**CONTRACT ADDENDUM #**

**date:** 5.10.24  
**project:** Hyde Park Middle School  
**by:** Michael Rigby  
**subject:** Addendum 02

**HPMS ADDENDUM #2**

**SUBJECT:** **Addendum #2 – Changes to Bid Package #1**

**A-111.0**

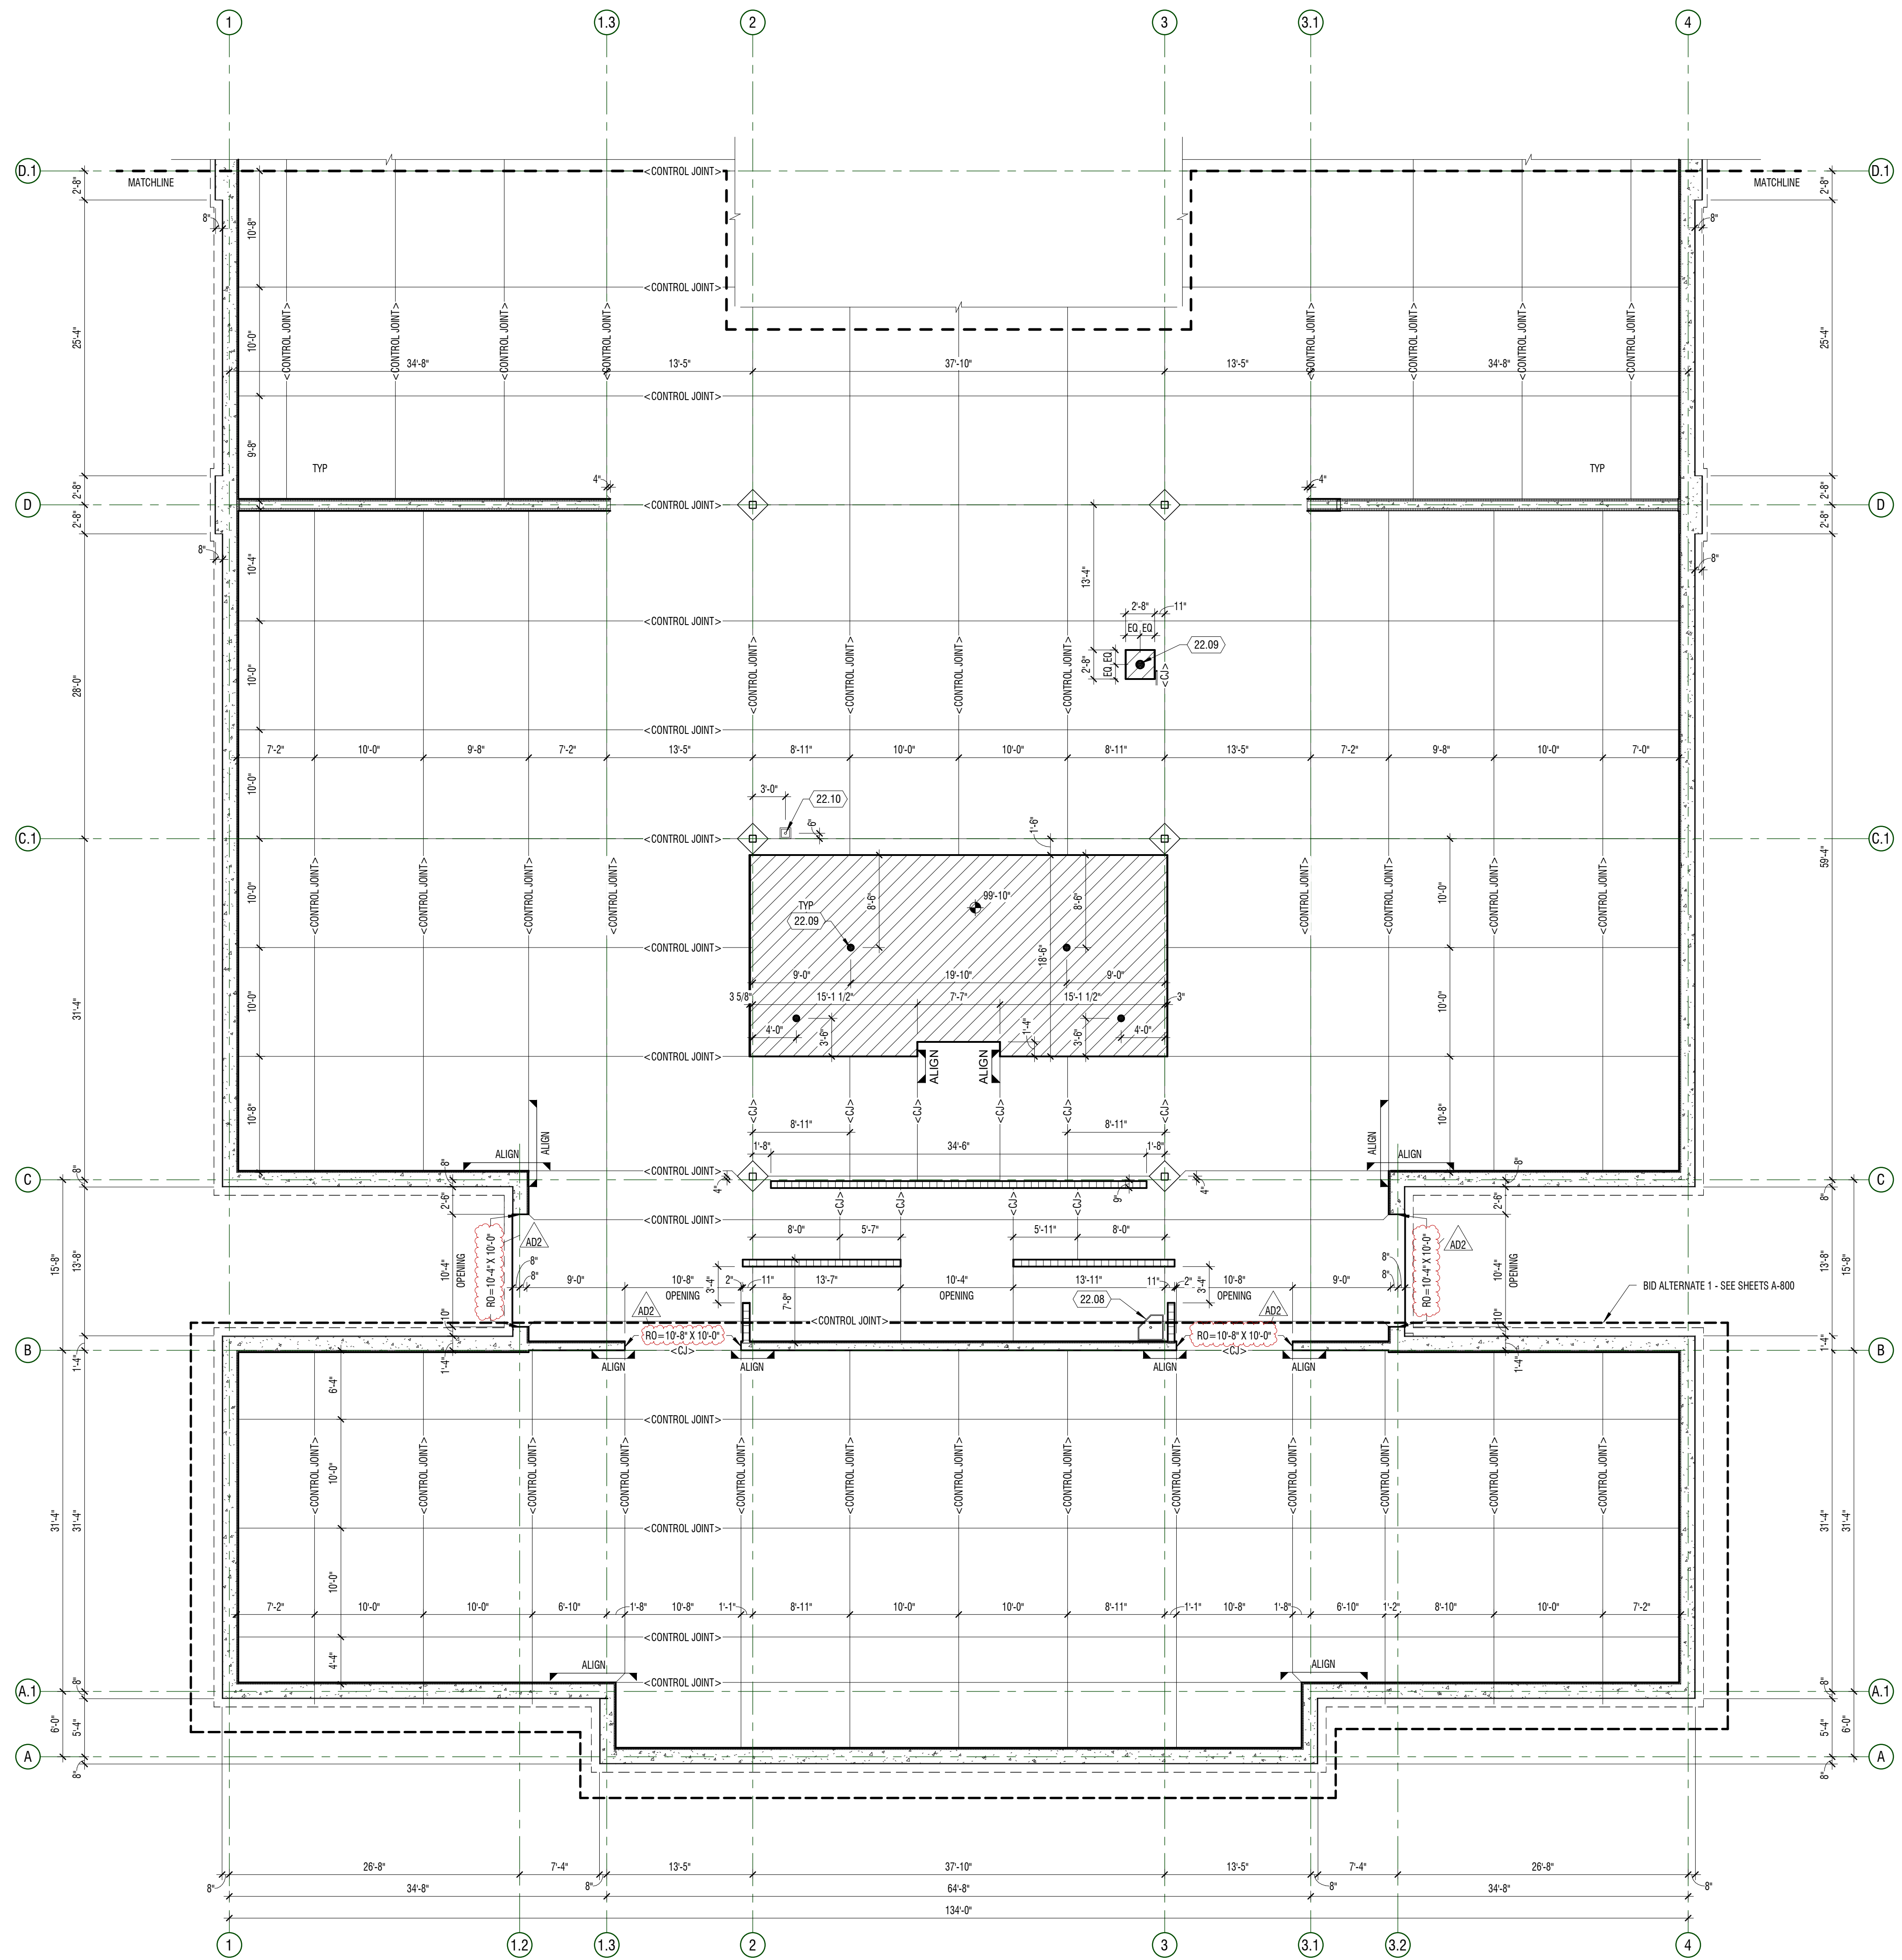
- 02.01      A-111.0 – PLAN – LEVEL 01 – AREA A – SLAB & FOUNDATION
  - ROUGH OPENING (RO) OF CONCRETE/ICF OPENING.
- 02.02      A-112.0 – PLAN – LEVEL 01 – AREA B – SLAB & FOUNDATION
  - ROUGH OPENING (RO) OF CONCRETE/ICF OPENING.
- 02.03      A-113.0 – PLAN – LEVEL 01 – AREA C – SLAB & FOUNDATION
  - ROUGH OPENING (RO) OF CONCRETE/ICF OPENING.
- 02.04      A-114.0 – PLAN – LEVEL 01 – AREA D – SLAB & FOUNDATION
  - ROUGH OPENING (RO) OF CONCRETE/ICF OPENING.
- 02.05      A-115.0 – PLAN – LEVEL 01 – AREA E – SLAB & FOUNDATION
  - ROUGH OPENING (RO) OF CONCRETE/ICF OPENING.
- 02.06      A-115.0 – PLAN – LEVEL 01 – AREA F – SLAB & FOUNDATION
  - ROUGH OPENING (RO) OF CONCRETE/ICF OPENING.
- 02.07      See attached Civil Items
- 02.08      See attached Structural Items
